Re: RFI Planning Retention Application.
Apts at Milstone House, Old Nangor Road, Clondalkin, Co.Dublin
Storm Water SUDS.

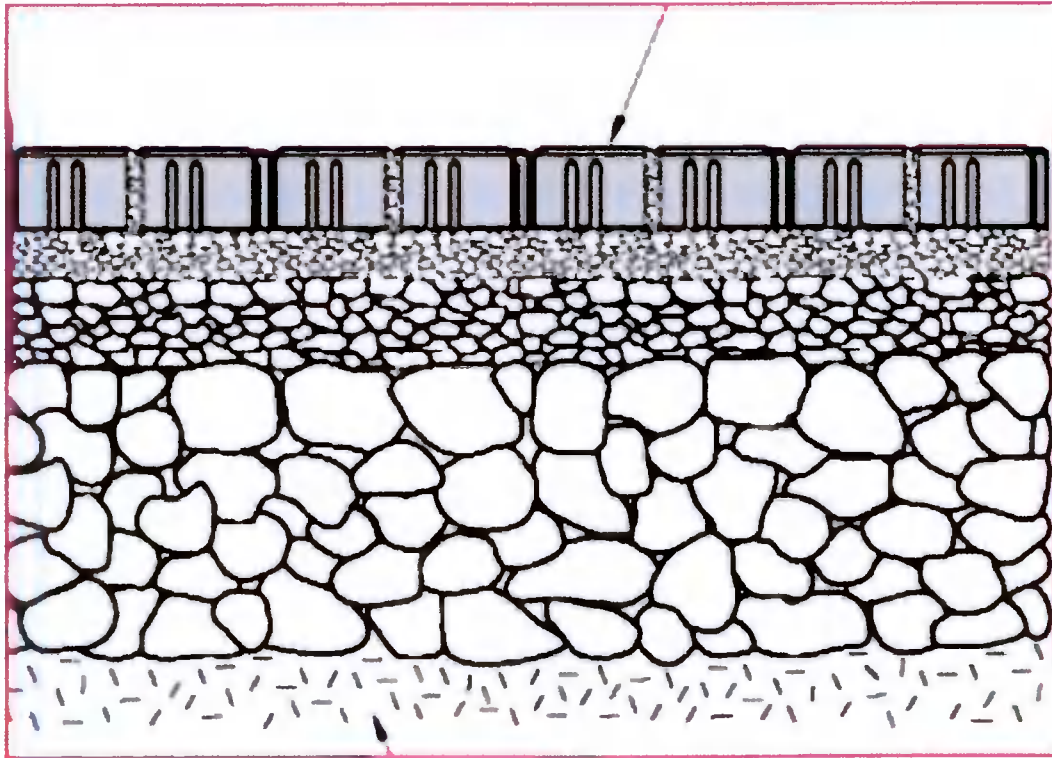
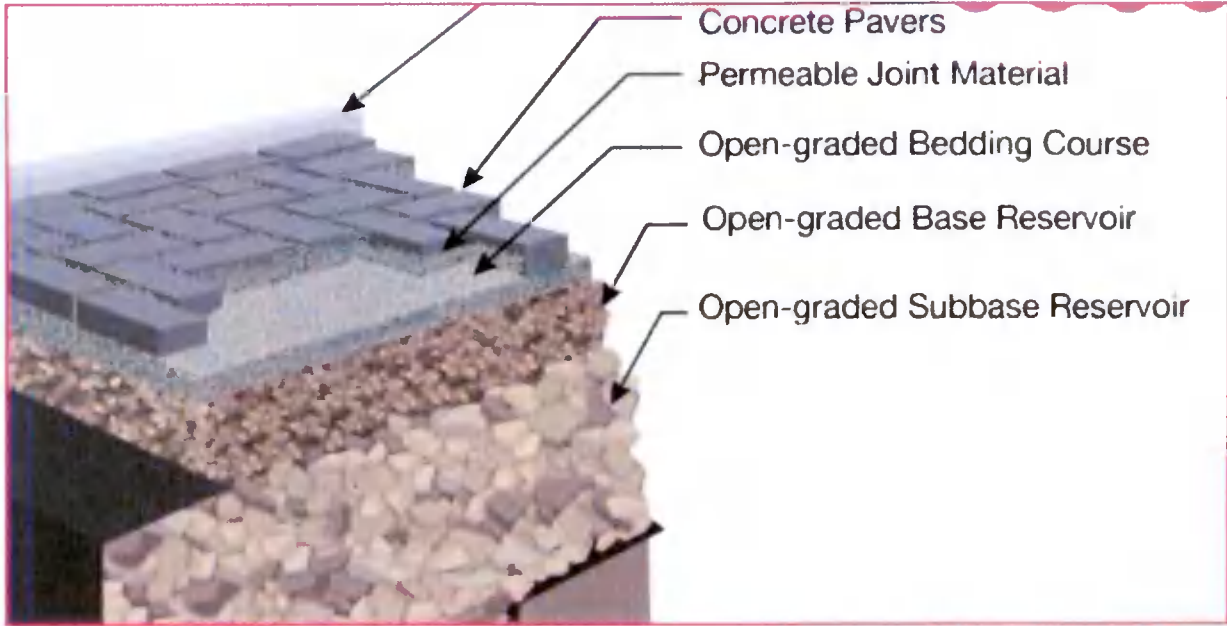
There is an existing paved area, within the site, at the rear of the building.

It is proposed to remove this concrete paving and to replace it with Permeable Pavement to provide a SUDS.

Also, see below details of proposed Permeable Paving proposed for the rear yard.

In general permeable paving is a preferred option to concrete because it is a SuDS feature.
